Service Information Bulletin

Introduction of DMC firmware version 11R3b7

DD+DIS169.15E

Figure 2

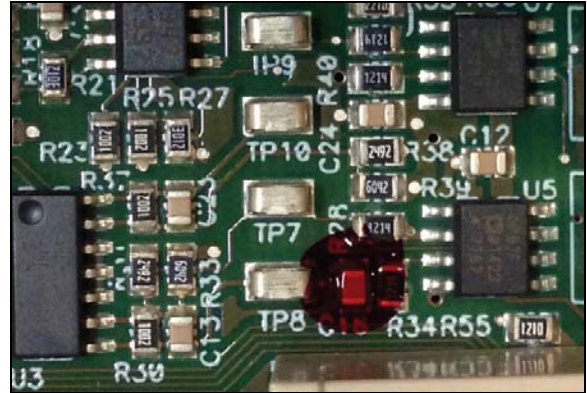
- After replacement it is necessary to protect the DMC board SAT-A3539-01 against possible damages, e.g. during voltage measurement at Test Point TP8. For that, it is necessary to apply a coating protection over the C16 capacitor before measuring the voltage. Use Loctite 7400 for coating.
- In case Loctite 7400 is not available, use a piece of electrical tape over the C16 capacitor. In case the tape is used it should be removed after adjusting the TP8 voltage.
